PRE-APPEAL BRIEF REQUEST FOR REVIEW

Application Number	Filed
10/593, 172	September 15, 2006
First Named Inventor	
Harold E Cutler	
Art Unit	Examiner
3771	Colin Stuart

ARGUMENTS FOR APPEAL

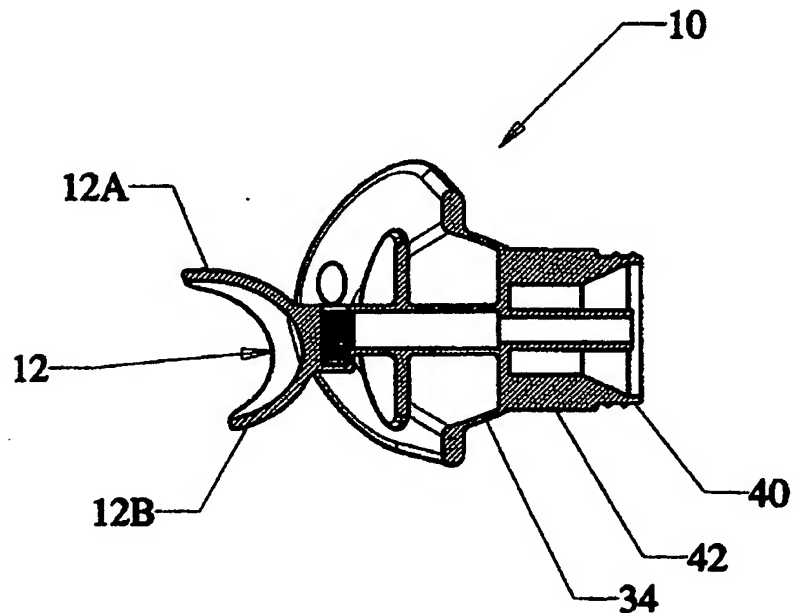
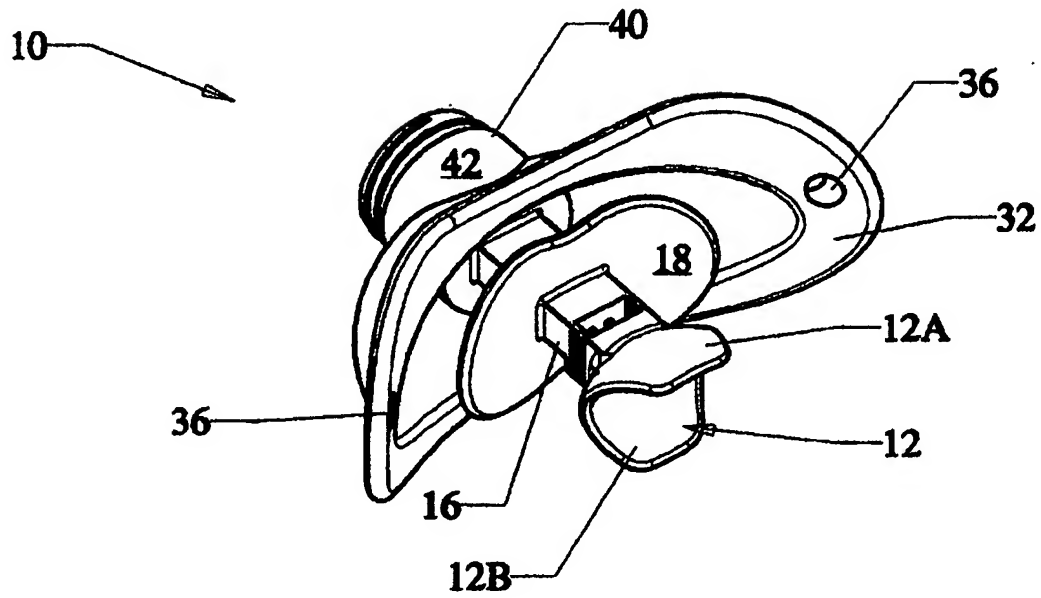
In examiner’s Response to Arguments, examiner writes in defense of the assignment of function as “palate member” to “12A” of Pivovarov, “...the anatomy of the human differs from person to person and a smaller or adult or child’s soft palate would be affected by the device”. There is no stated purpose in Pivovarov for “12A” to affect the soft palate, and no limitation as to size of the user of the device. Examiner’s argument that accidental and unintended contact with the soft palate due only to the size of a user of a certain stature is sufficient foundation for applying the function of “palate member” to “12A” is improper reasoning under *in re* Orlich as well as KSR v Teleflex as referenced above. Appellant finds reversible error in the rejection of Claims 6, 12, 15-17.

The description “ending in a declined portion” was added to the description of the palate member in the instant application to differentiate it from component “12A” in Pivovarov. This was suggested by examiner during the interview on June 16, 2009. In the final rejections, examiner defines “12A” of ‘430 as having a “declining upwards angled portion” and uses this confusing interpretation as a basis for rejection. The portion cannot be “angled upwards” and declining, or angled downwards (as presented in Claims 6 and 12, and supported by the Figs.4 and 5 in the instant application), at the same time. In support of the rejection, examiner points to Fig. 1 of ‘430 which is drawn in perspective with the entire device on a pronounced downward angle (Appendix, Page 1). Even so, it is obvious that there is no portion of “12A” that is declined, or angled downward in the direction the rear of the oral cavity. The lack of a “declined portion” is further exemplified by Fig. 4 of ‘430 (Appendix, Page 1) which is the only figure in Pivovarov drawn on a true horizontal axis, as well as Fig. 9 of ‘430 (Appendix, Page 2). Examiner further states that the “soft palate member” in Pivovarov “maintains contact with the soft palate of the wearer”. Figure 9 shows no such relationship as a soft palate is not even depicted in the drawing.

No "declined portion on "12A"

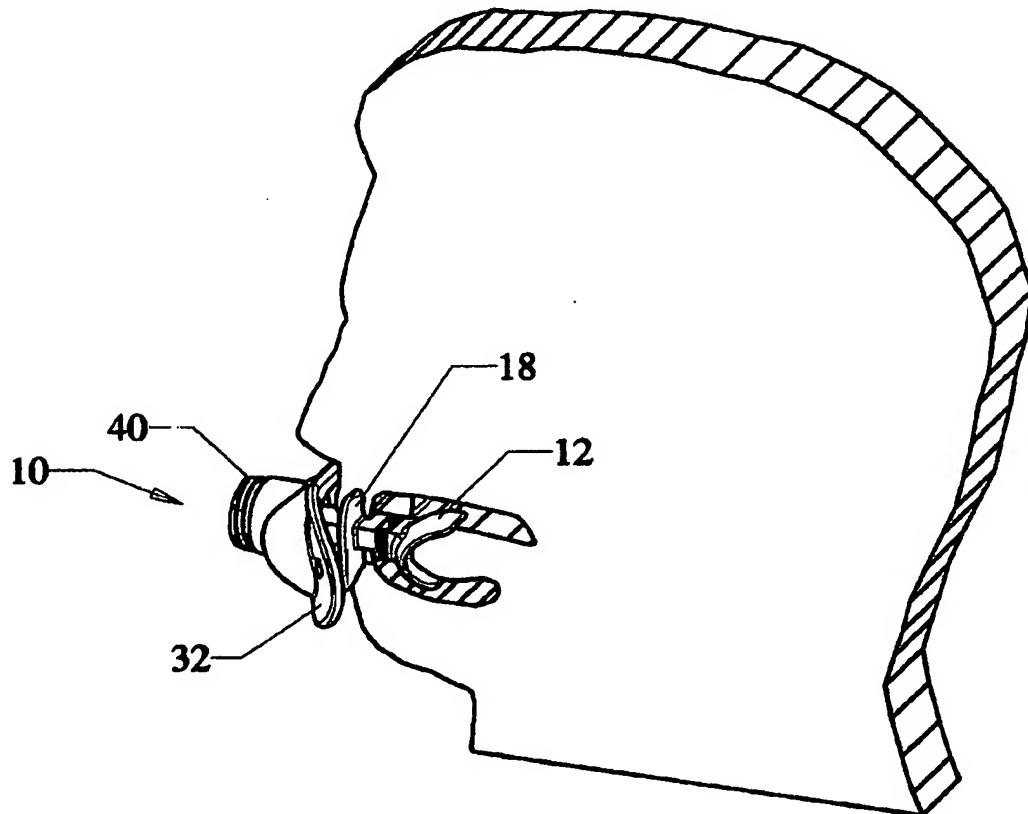
No “declined portion” on “Lobe A” of Structure 12.

Lobe “B” is clearly under the tongue.

As positioned, the cup formed by Lobes A and B of structure 12 would keep the tongue from moving forward and provide no restriction to rearward movement.

There is no soft palate depicted.

If the soft palate was shown and properly located, it would be above the very rear of the tongue where it curves downward. That is at a point farther into the oral cavity than is depicted in this drawing.
